Trim Gauge Reading Opposite

QUICKSILVER KIT PART NUMBERS

Figure 1 - Date Code Location

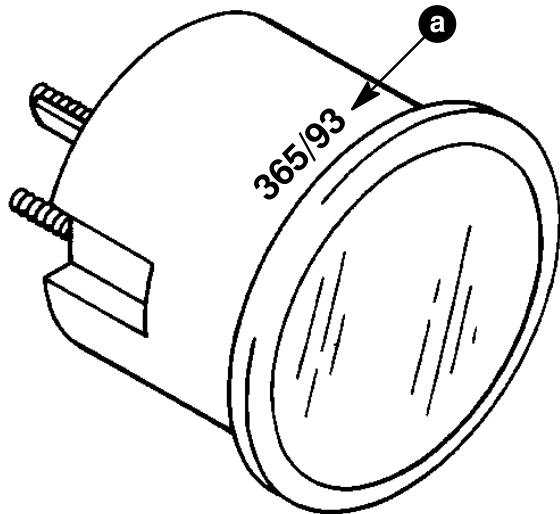
A number of trim gauges contained in the kits listed above have been manufactured incorrectly. Symptoms of the subject gauge are: the needle moves in the opposite direction of the outboard when trimmed in or out.

These kits/gauges are used on Mercury/Mariner 40 to 125-HP single-ram power trim systems. The affected gauges will have a date code of 365/93 and prior.

a. - Date Code

Replace trim gauges that have the listed date code of 365/93 and prior.
